**Technical Service
Information Bulletin**

**FRONT STABILIZER BAR
ABNORMAL NOISE**

'00 – '02 GS 430/400/300 & '02 SC 430

**SUSPENSION
SU003-02
REVISED**

**Bolt
Locations**

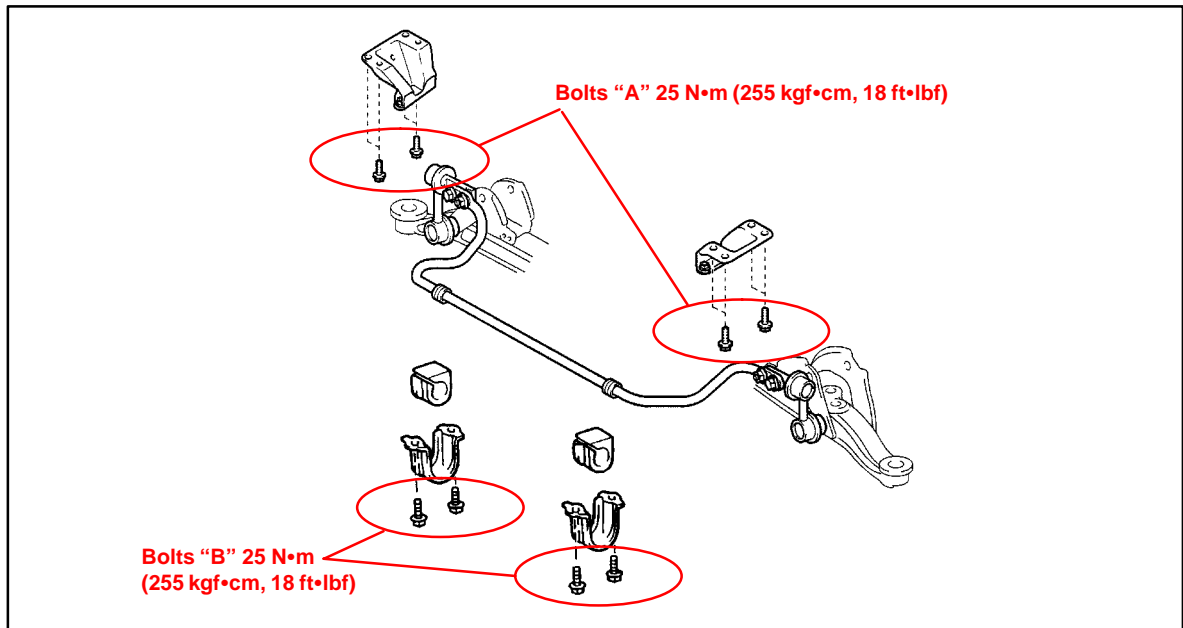
Introduction To eliminate abnormal noise by the front stabilizer bar when driving over bumps and/or cornering, the bolt tightening torque of the mounting hardware must be checked and adjusted if below specification.

Do not apply any foreign material (such as thread locking compound or lubricant) to the bolt threads before tightening the bolts to the proper torque value.

PREVIOUS PART NUMBER	CURRENT PART NUMBER	PART NAME	QTY
90119-08C02	Same	Bolt (Front Stabilizer Bar Bracket "A")	8
90119-08C04	Same	Bolt (Front Stabilizer Bar Bracket "B")	4
